**Appraisal of Design Proposals**  
**New Barnet Victoria Quarter**  
for the Save New Barnet Group

**August 2021**

Revision A: September 2021

**Study of the communal gardens , referring to guidelines in National Model Design Code**

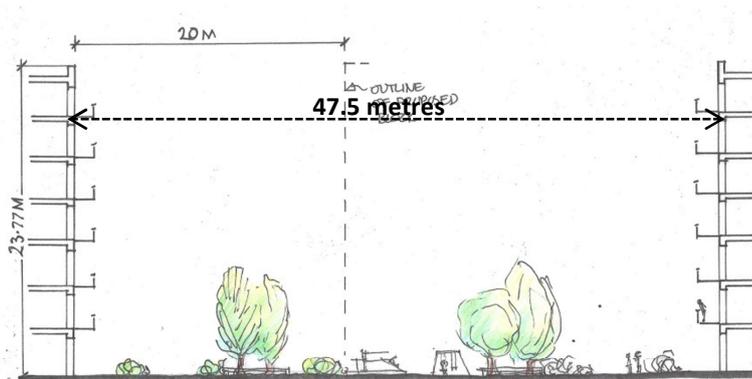
The only section through the communal gardens (left) shows Block B2 (six storeys). In fact, the majority of the garden is dominated by seven storey apartment blocks (shown as a dotted line) on either side at a distance of only 20 metres. The separation distance between balconies is 17 metres.

**Elevation of apartment blocks from Victoria Recreation Ground: Blocks are not stepped down towards the park so there is no mediation in scale. The change in brick colour is deceptive; it does not indicate a set back**

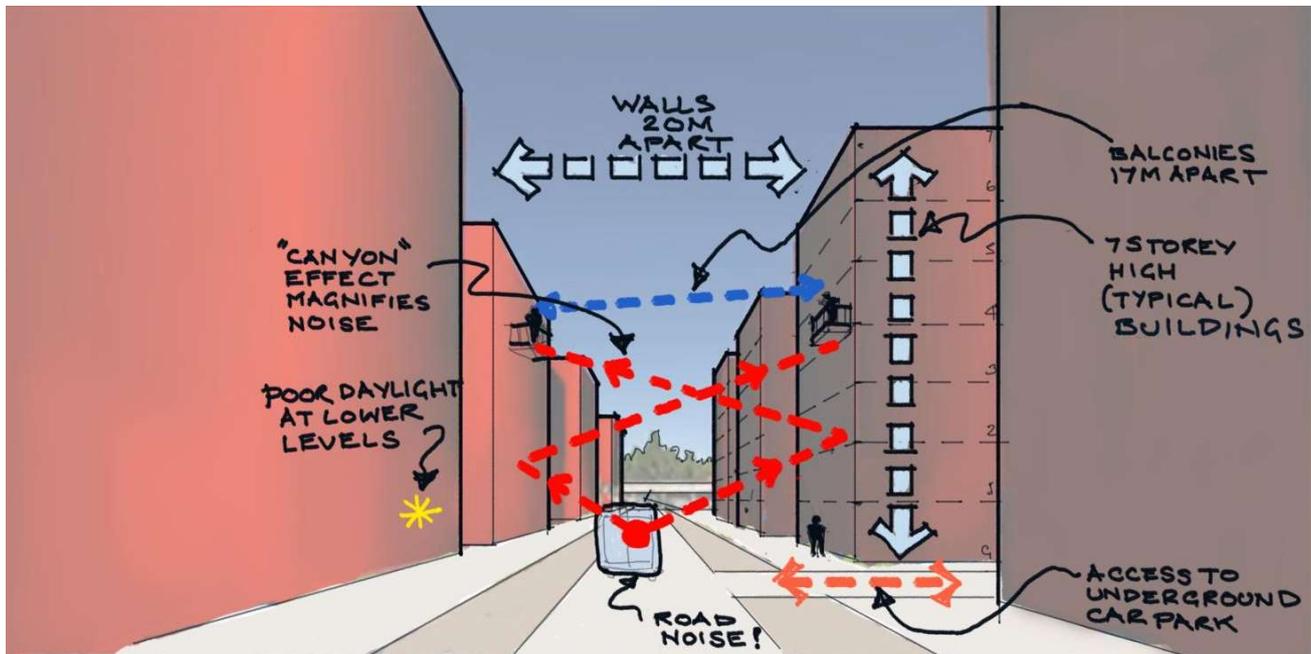
**The verified view in the DAS, when shaded in, gives a more representative impression of the effect the new development will have on the park.**

Many of the verified views in the DAS show only a dotted line, underplaying the impact of the development on surrounding spaces. This impact will have a particularly detrimental effect where apartment blocks sit on the boundary with Victoria Recreation Ground.

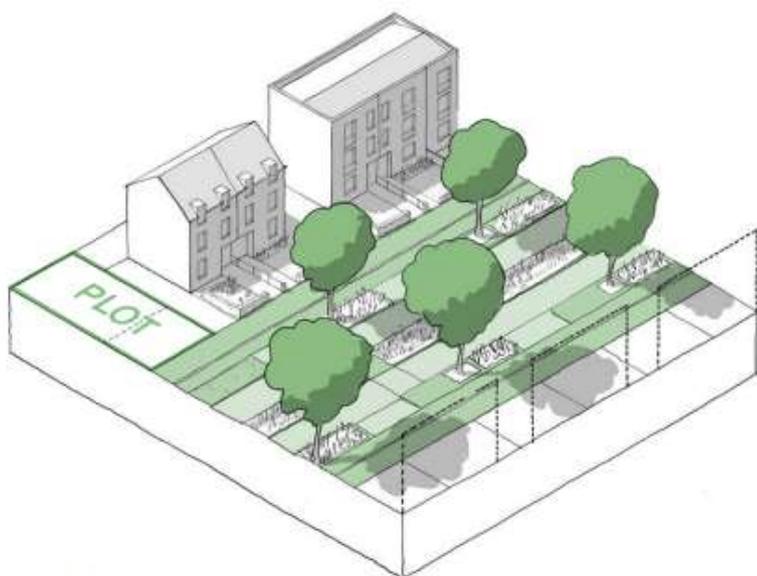
Buildings along Spine Road face each other at a minimal twenty metre distance and only two of the eight blocks are lower than seven stories. Spine Road bears no resemblance to the suburban primary street illustrated in the National Model Design Code (next page) which shows a wide, tree lined street. And just as the guidance for public squares suggests an appropriate relationship between the heights of buildings and the spaces they address, the same principles are applied to streets:

Spine Road is not a high street. Following this guidance, an eaves height of just ten metres would be appropriate. Conversely, maintaining building heights of 23.77 metres would require a road width of 47.5 metres

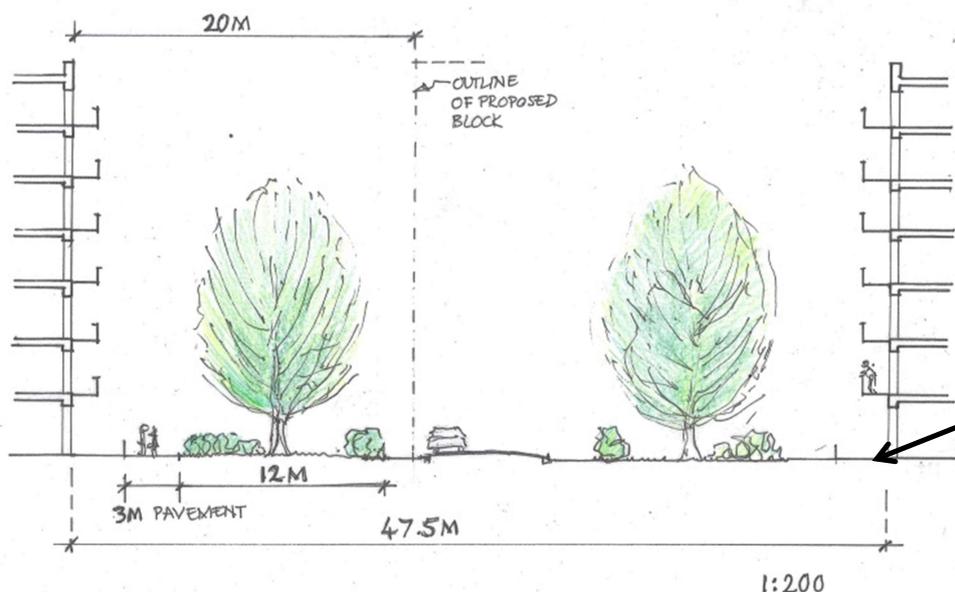
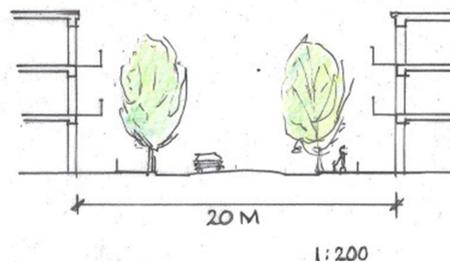
Below left: a distance of 20 metres between blocks results in narrow pavement widths and allows for only small trees to be planted (which do not act as a wind break for prevailing wind). Noise is trapped between buildings creating a noise canyon. The distance between balconies is only 17 metres

Below right: according to the National Model Design Code, to retain comfortable proportions, three storey buildings would be appropriate for a road width of 20 metres in a suburban area

Above: Following guidelines for the ratio of building height to street width (in a suburban area) means that buildings of seven stories should address a generously proportioned avenue – 47.5 metres wide. This allows for wide pavements and planted areas which contribute to urban greening. Mature trees will make a genuine contribution to the wind microclimate by acting as a wind break (see Section 7.4) and help provide privacy for flats which face each other. There is more room for noise to disperse thereby avoiding the ‘noise canyon’ effect seen in Spine Road.

Wind microclimate diagram (above)

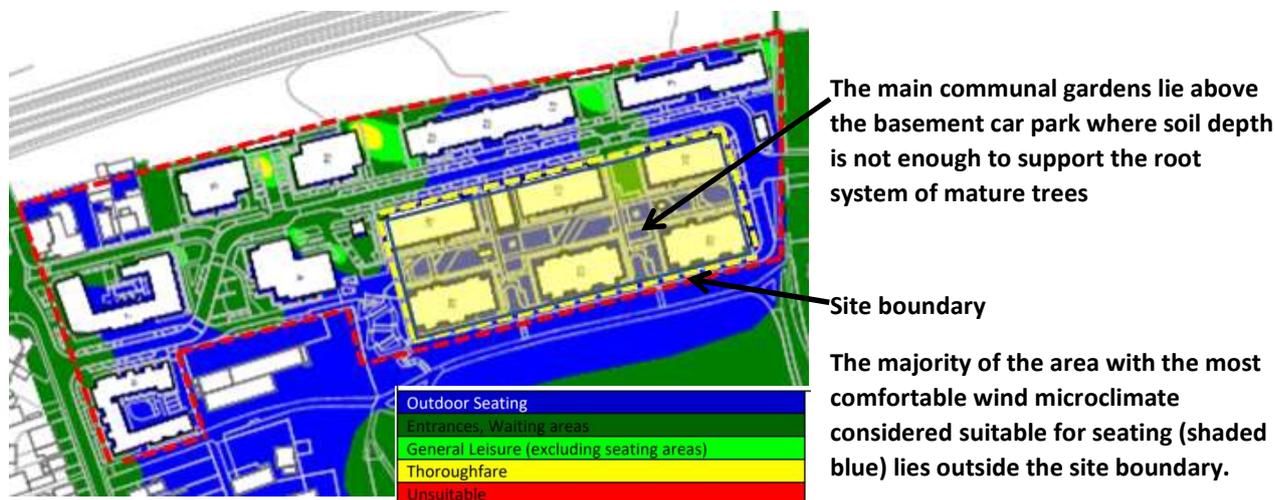
Taller buildings can create a windy microclimate. Looking at the analysis (below), it appears at first glance that levels of comfort are good but in fact the majority of the area regarded suitable for outdoor seating (shaded blue) lies outside the site. The orientation of the blocks also means that *'There remains potential for channeling of prevailing south-westerly winds along the western elevations and through the gaps between the blocks, into the site'*(Wind Microclimate Report)

The predicted microclimate depends on mature planting, including trees; the report states that, *'The current assessment assumes that the trees will be planted semi-mature and be of a deciduous species with substantial canopies ... such that the landscaping proposals are expected to be beneficial in helping alleviate wind flows across the site.'* However, the main communal gardens lie above the basement car park –and soil depth here of only 450mm is not enough to support the root system of larger, mature trees which will therefore need to be planted in large, raised beds. Moreover, The DAS states that, *'Within the Courtyards, the approach is to use smaller, multi-stem trees.'* Illustrations of the garden area (below) suggest that these may not be as effective in terms of providing a wind break as the trees with *'substantial canopies'* needed to *'alleviate wind flows'*.

Many of the areas shown as suitable for outdoor seating do not have the mature trees with *'substantial canopies'* which are required in order to achieve these comfort levels. Illustrations of the communal gardens show *'smaller, multi stem trees'* and, in Spine Road, smaller trees have been specified which are *'well suited along narrow street avenues'*. These are unlikely to have any significant impact on the wind microclimate.

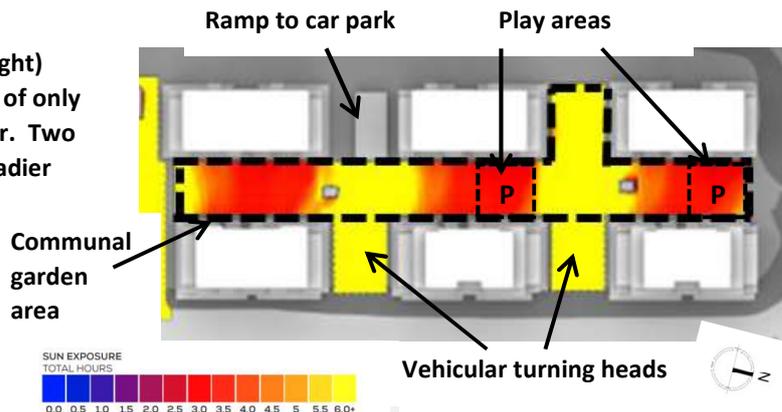
The overshadowing diagram for 21<sup>st</sup> June (right) shows that half the garden gets a maximum of only three hours sunlight in the height of summer. Two children’s playgrounds are located in the shadier areas making them less pleasant to use.

Areas between the ends of blocks are sunnier but are utilized as the ramp to the car park and turning areas for the service road

15. Appendix 5: Noise Contours across the Proposed Development Site

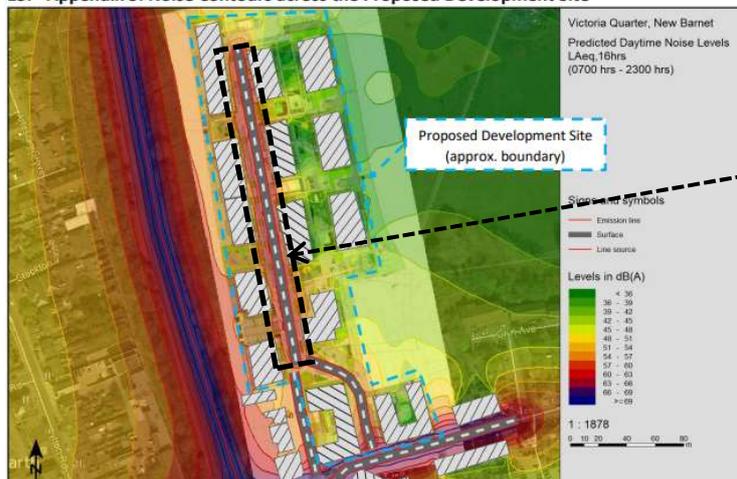
The acoustic diagram (below) shows a concentration of noise along Spine Road. This is typical of the acoustic effect of an urban street, with tall buildings to either side effectively trapping noise, creating a 'noise canyon'. This noise problem, generated by the design, was also a feature of the refused application; retaining the same overall layout and height strategy (six out of nine blocks on Spine Road are seven storeys or more) means that there have been no design modifications which address this problem.

Noise levels of between 57 and 60 dB are predicted on Spine Road, effectively creating a noise canyon.

**Top-heavy appearance**

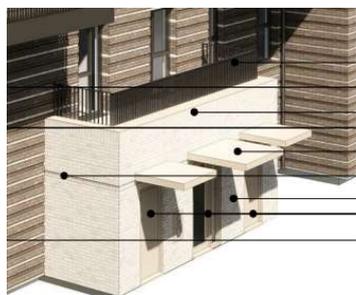
Top floors, which could be treated as an attic storey look heavy with an additional band of brickwork above the windows to conceal lift machinery. An alternative approach, used in the consented scheme, would be to use a more lightweight material -metal cladding perhaps – and set back the upper floors, referencing an ‘attic’ storey.
